# SERVICE BULLETIN

No. 109

Date February 4, 1960

**Subject:** Addition Of Drain Holes, Concerning All Ercoupes, Aircoupes, and Fornaires Up To Serial #5714

FIG. 1.

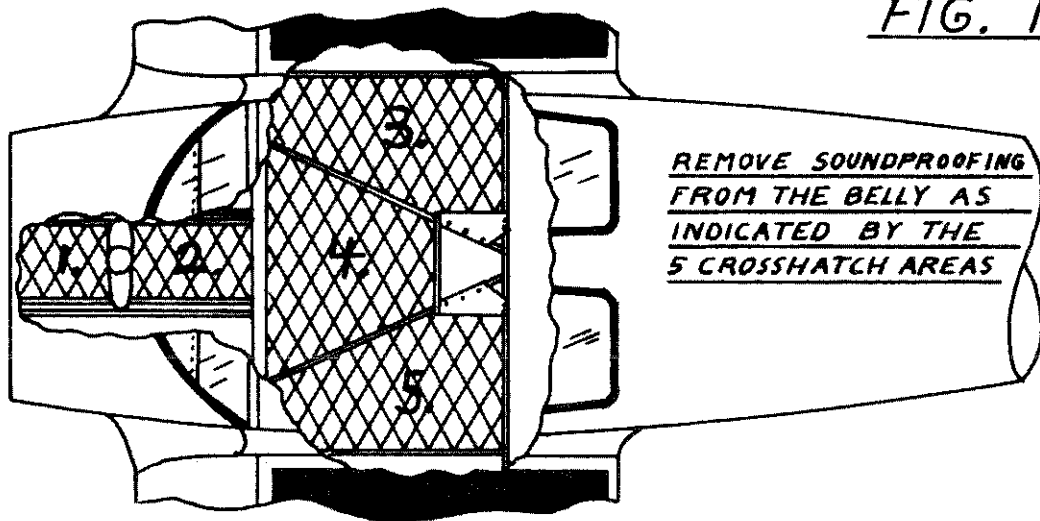
- c. Remove (if present) all soundproofing in the lowest belly regions as shown in Fig. 1.

Note: Tests have been conducted and the result of increase noise upon removal of soundproofing in these areas is negligible. Therefore, do not replace the soundproofing. This will enable unobstructed drainage and prevent water from being held by absorption into the soundproofing.

FIG. 2.

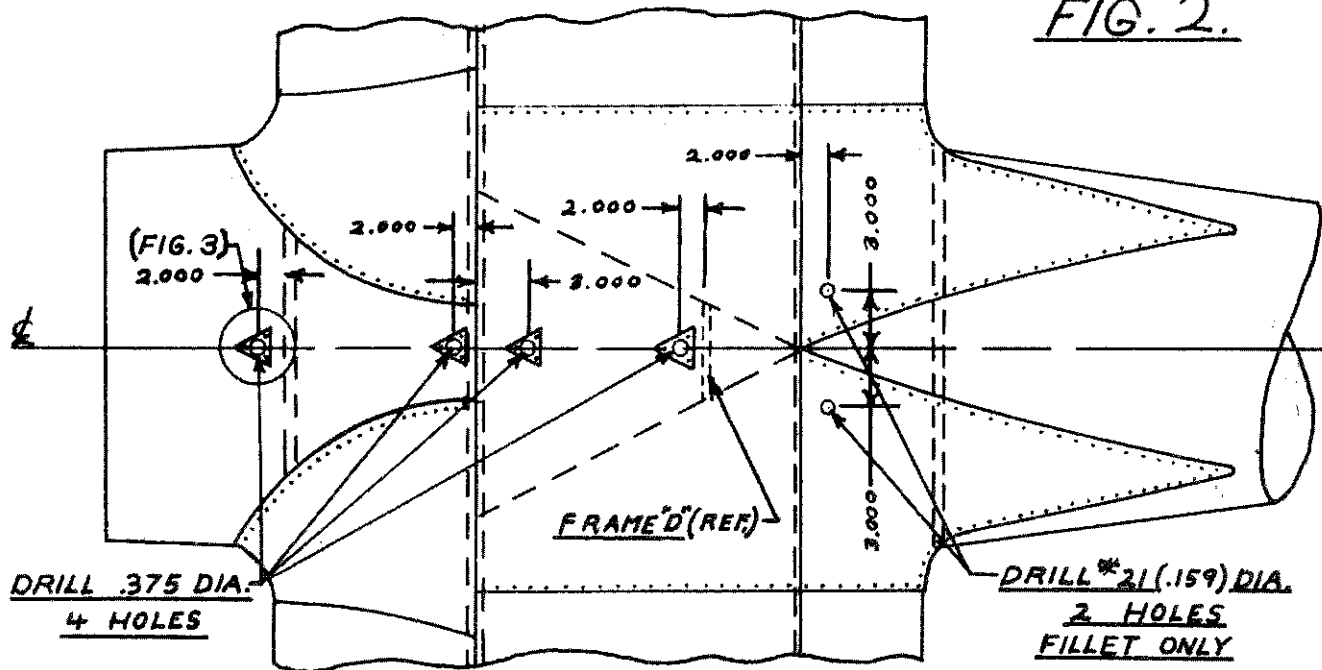
- d. Locate and drill six (6) drain holes as per Fig. #2.

- e. Install with AN-470AD3-3 rivets (alternative cherry rivets #CR163-4-3) four (4) clam shell cover plates as located per Fig. #2, and shown in detail per Fig. #3.
